Addition of Quantization Noise in COM

Supporting Document for Comments #360-370 Against Draft 1.3

Hossein Shakiba

Huawei Technologies Canada

Figure 178A-7—Sources of noise considered in calculation of COM

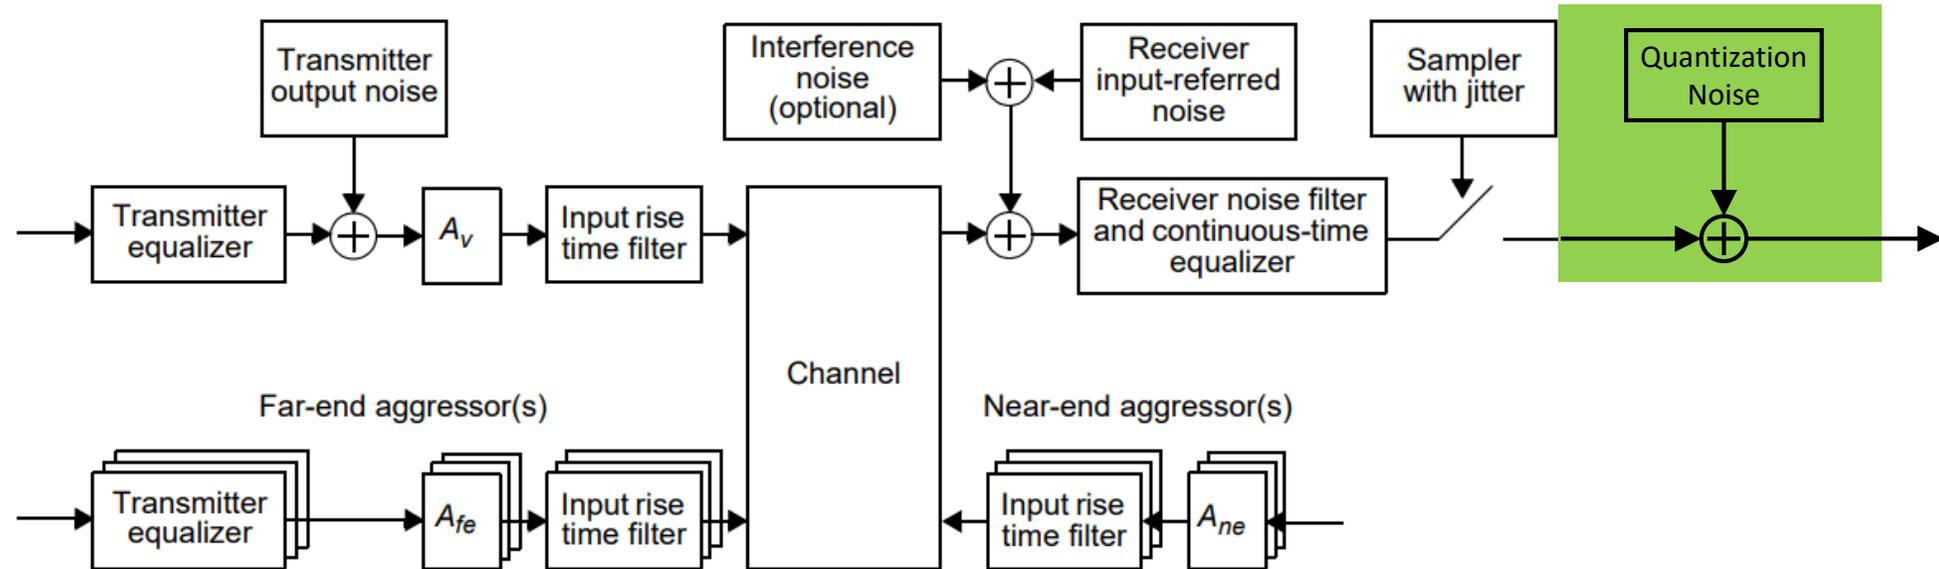
- Comment #361:
 - ❖ Page 754, Section 178A.1.7, Figure 178A-7
 - ❖ Add quantization noise to the figure

Figure 178A-9—Receiver discrete-time equalizer

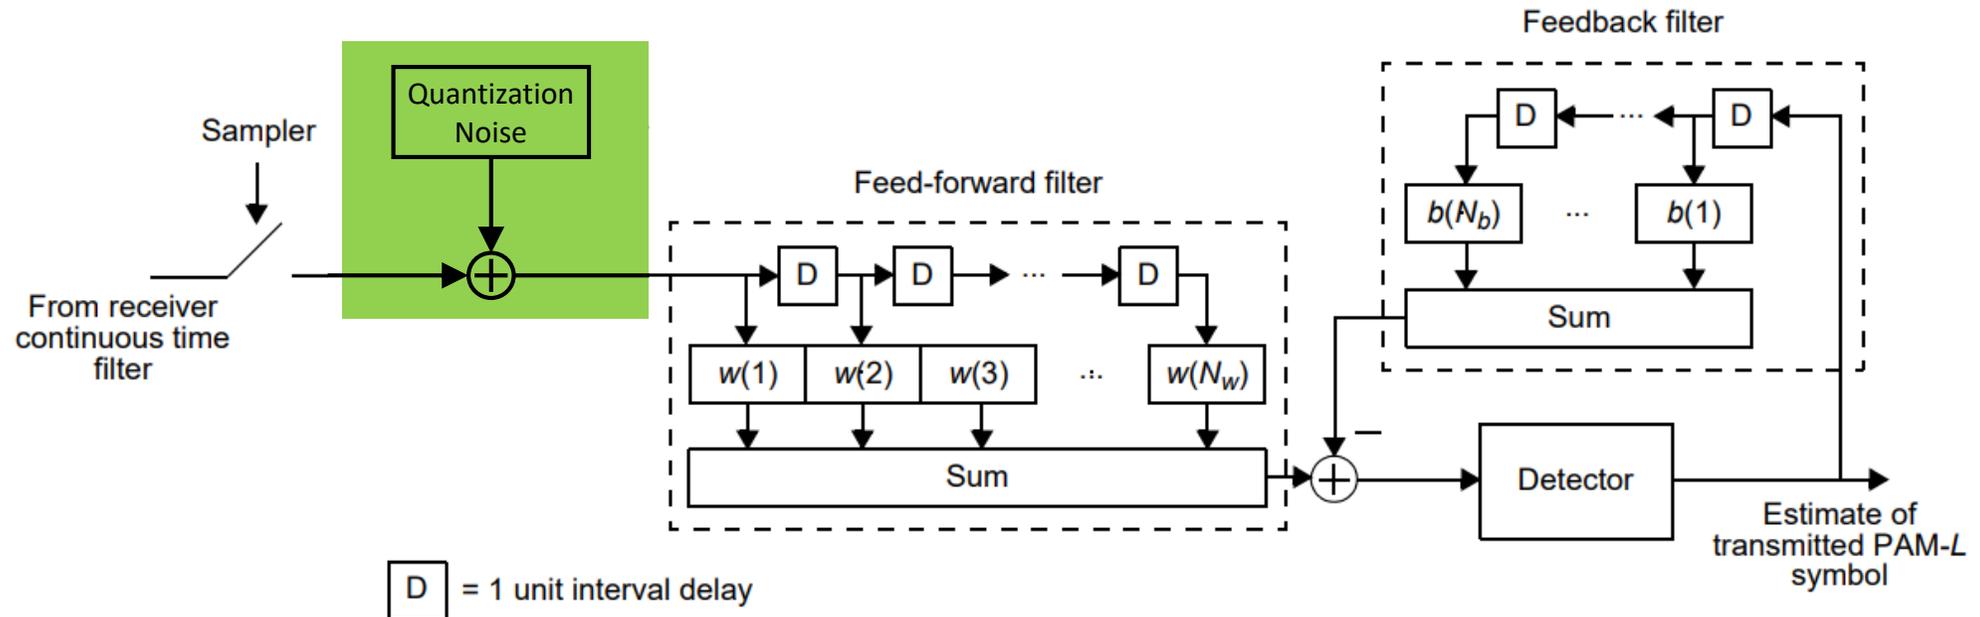
- Comment #367:
 - ❖ Page 758, Section 178A.1.8.1, Figure 178A-9
 - ❖ Add quantization noise after sampler

Figure 178A-10—Receiver discrete-time equalizer with MLSD

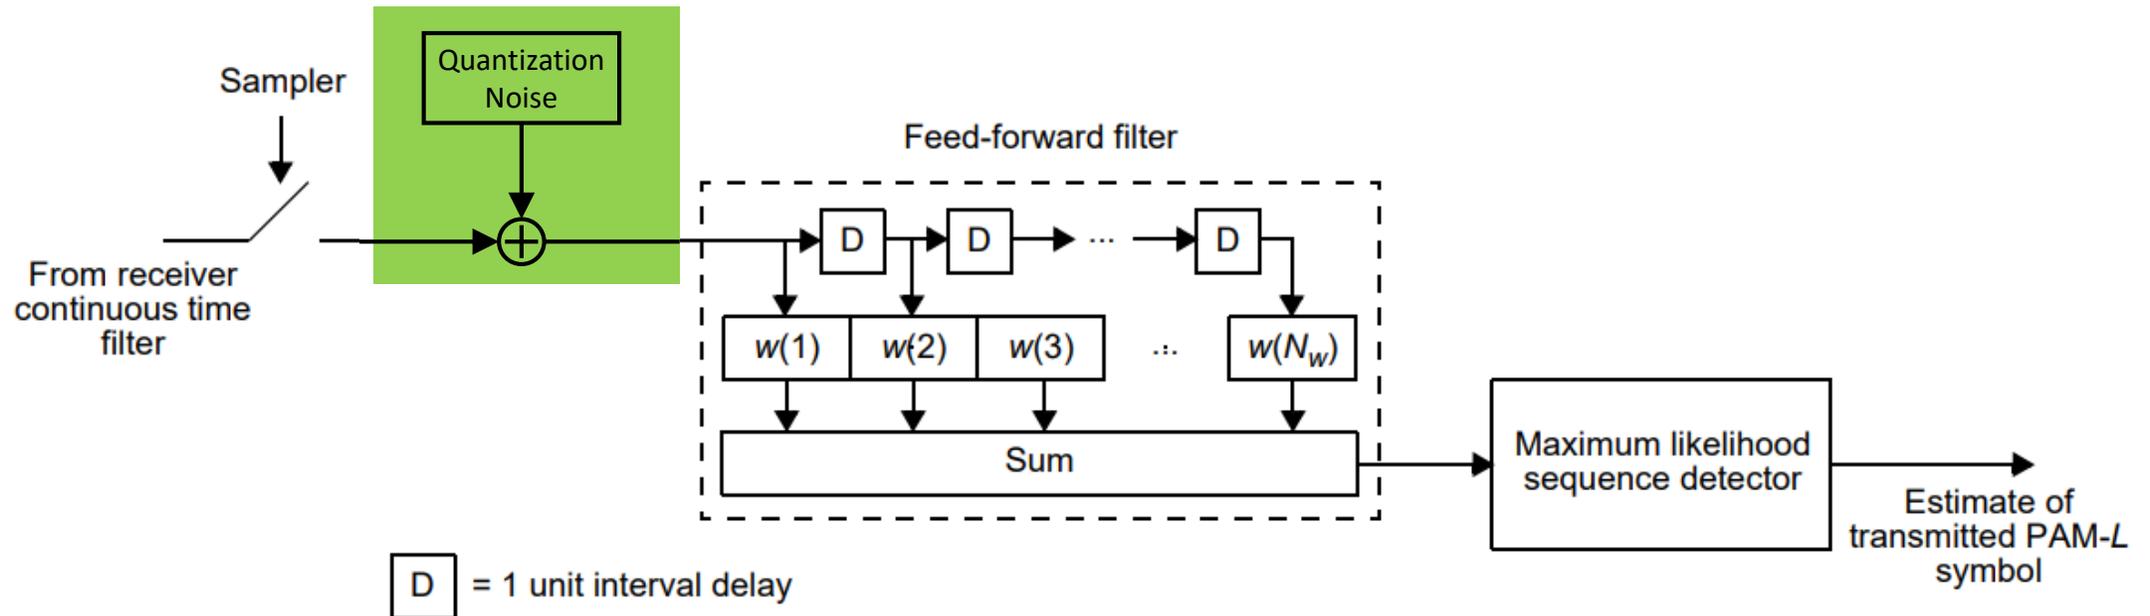
- Comment #370:
 - ❖ Page 762, Section 178A.1.11, Figure 178A-10
 - ❖ Add quantization noise after sampler
